City of Jonesboro Metropolitan Area Planning Commission
Staff Report – RZ 10-21: Abernathy-PD-RM
 Huntington Building - 900 W. Monroe
For Consideration by the Commission on March 8, 2011 (Previously Tabled)

PURPOSE: A request to consider recommendation to Council for a rezoning from R-2 Low Density Multi-family to PDM- Planned District Multi-Family.

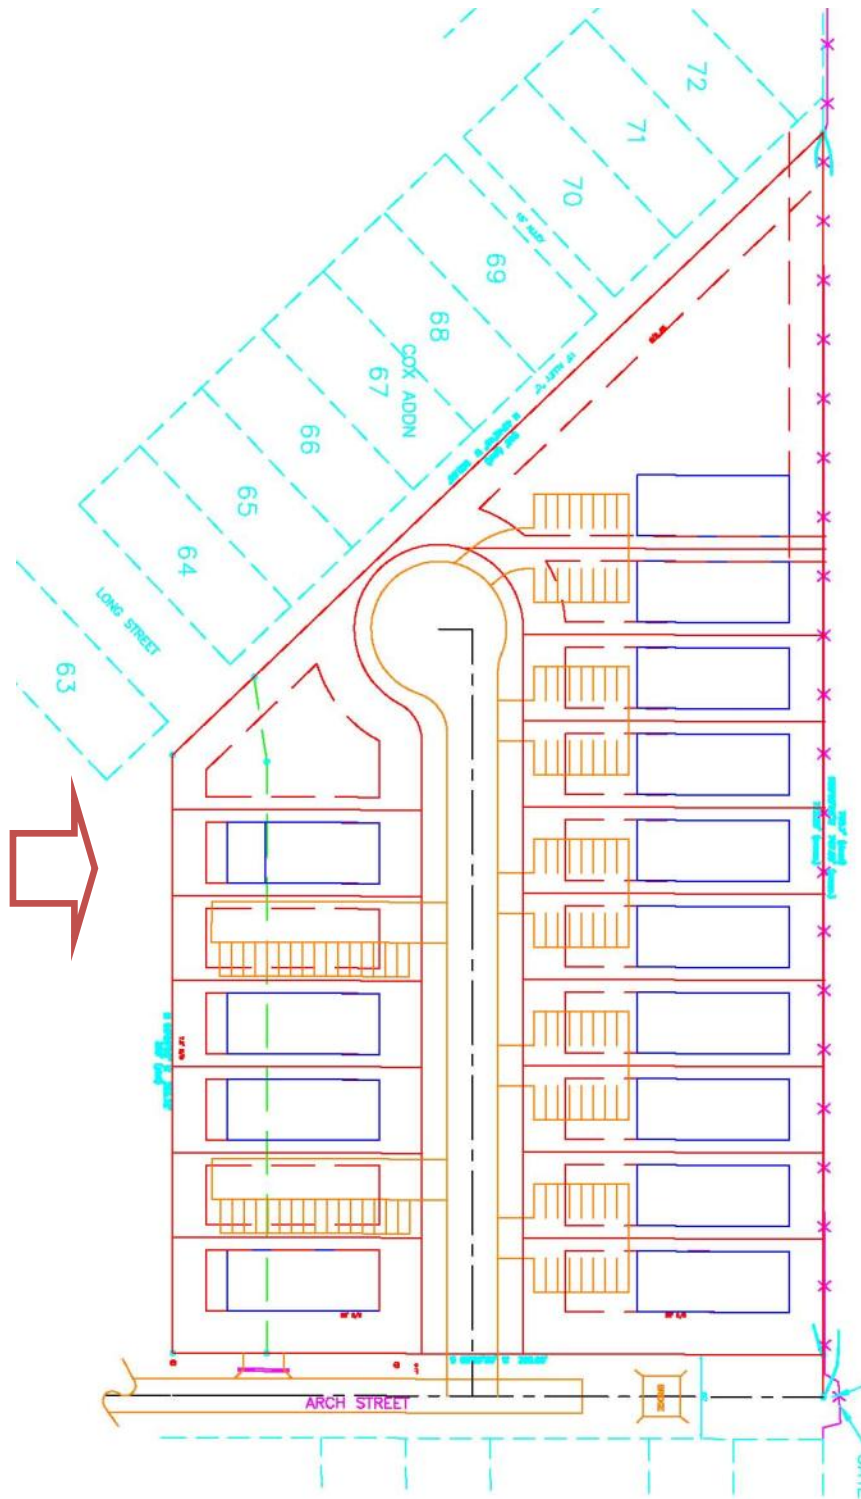
The applicant proposes to create a Planned Development- Residential (PD-RM). There are fifty-six (56) units proposed with no more than four (4) units per building.

Required Greenspace = 20%

Density: Proposed: 11.7 units/per acre

14 Buildings- 1- Bedroom Units/ single story buildings
1 Bedroom Units- 56

Parking: 130 Parking Spaces

Required= 1.75 spaces per 1 Bedroom Unit
56- 1 Bedrooms – 89 Spaces Required; 114 spaces are provided.
